Service Bulletin

Title: SB 429-206 Bell 429 Condenser Fan Motor Mount Fastener Inspection

Applicability: Bell Helicopter Textron Canada Limited 429 Aircraft equipped with any Air Comm Corporation 429EC-204 or 429EC-206 Air Conditioning Systems.

Figure 1

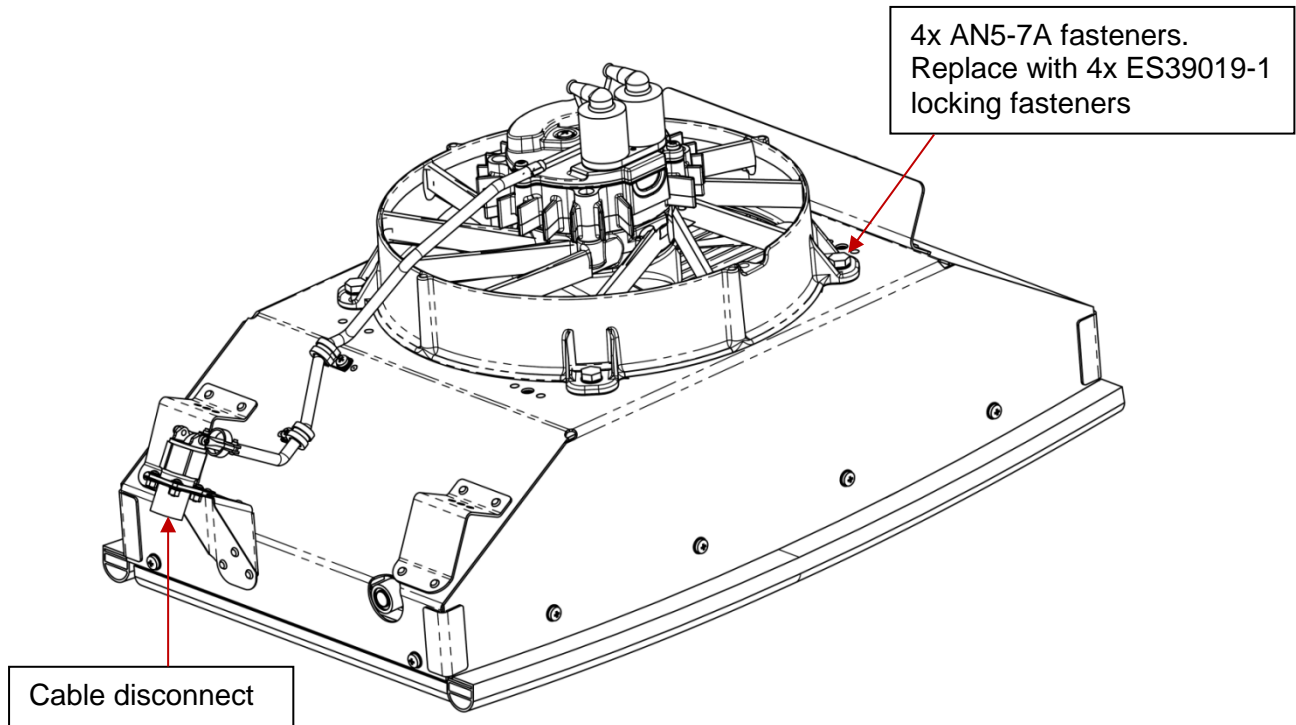
2. Remove the condenser assembly from the aircraft per 429EC-200M-1 Instructions for Continued Airworthiness.
3. Remove the condenser blower assembly from the condenser assembly by removing 4x AN5-7A fasteners and disconnecting the cable. See Figure 1 for location of AN5-7A fasteners and cable disconnect.

Figure 2

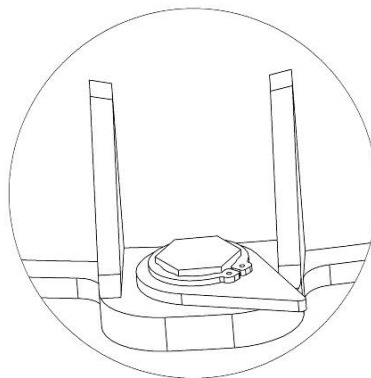
5. Reinstall the condenser blower assembly onto the condenser blower assembly with 4x ES39019-1 anti-rotation fasteners. Torque bolt from ES39019-1 to 100-140 in-lbs. Place anti-rotation retainer from ES39019-1 over top of bolt head, orienting anti-rotation retainer full counterclockwise as shown in Figure 2. Attach snap ring from ES39019-1.
